CERTIFICATE OF APPROPRIATENESS

Property: 416 Euclid St, Lot 4, Block 12, Woodland Heights Subdivision. The property includes a historic 1,176 square foot one-story wood frame single-family residence and a detached garage situated on a 5,000 square foot (50' x 100') interior lot.

Proposal: Alteration – Addition

Recommendation: Denial - does not satisfy criteria 1, 4, 8, 9, & 10

NORTH ELEVATION – FRONT FACING EUCLID STREET

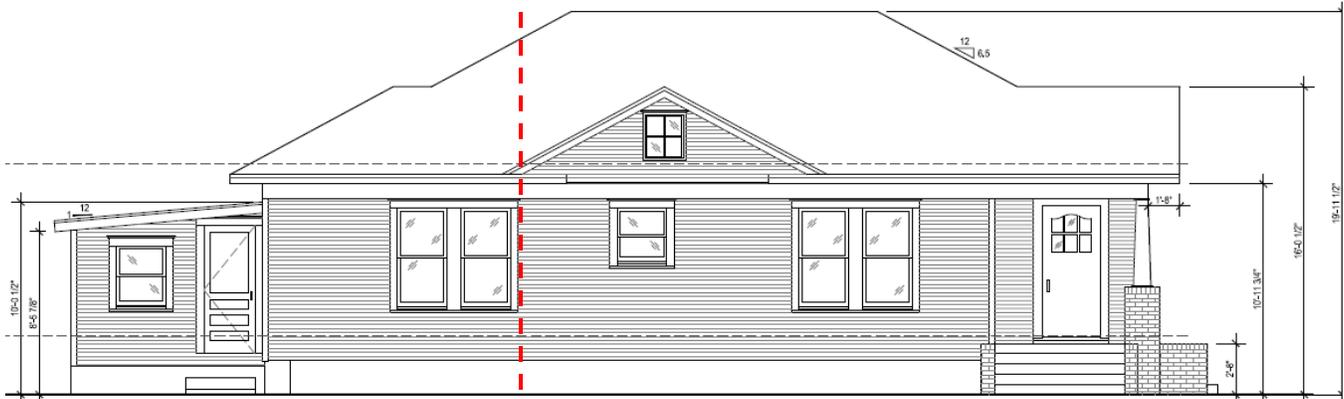
<i>Constructing a second-story addition on top of the existing residence results in a more visually dominant addition from the right-of-way and does not maintain the massing, size, scale, material and character of the one-story property.</i> |

WEST SIDE ELEVATION

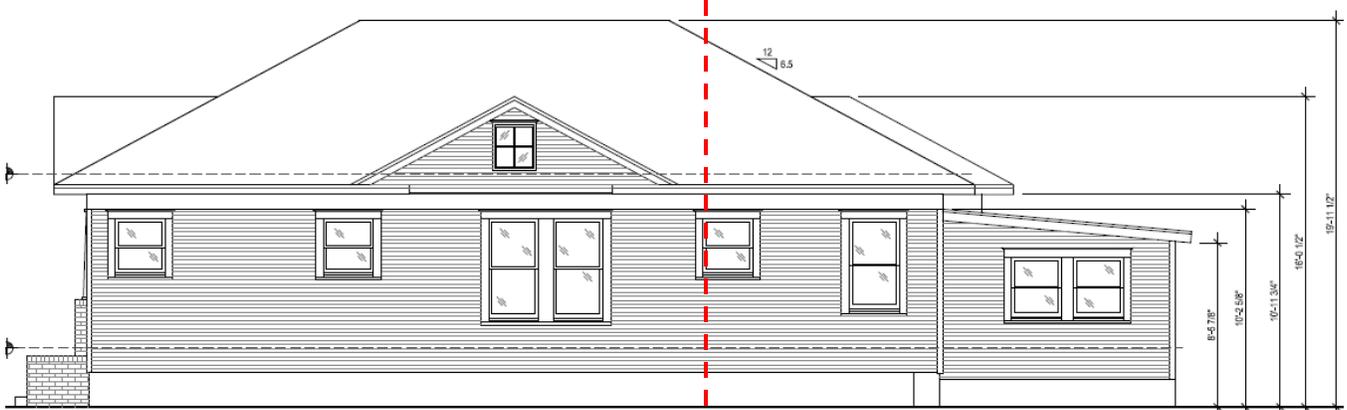
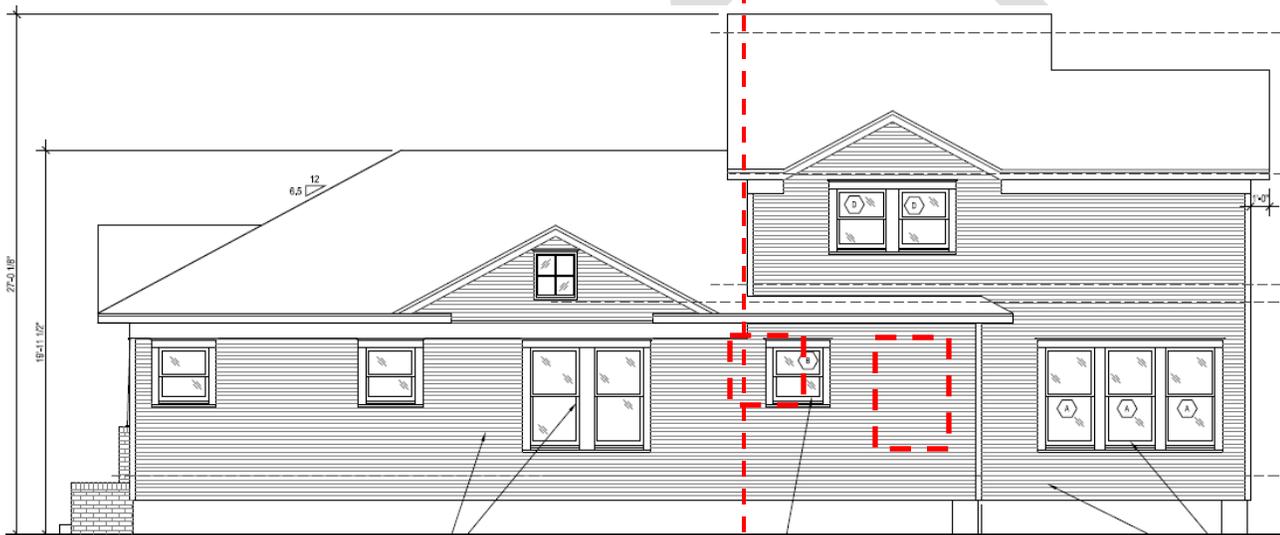
<i>The encroachment of the second-story addition onto the original structure results in a more visually dominant addition that also removes and shifts original windows. Therefore the alteration does not retain the historical character of the property.</i> |

<i>The addition and changes to the fenestration will likely remove interior shiplap, exterior siding and original windows.</i> |

1 WINDOW SHIFTED TOWARDS THE REAR;
1 WINDOW REMOVED
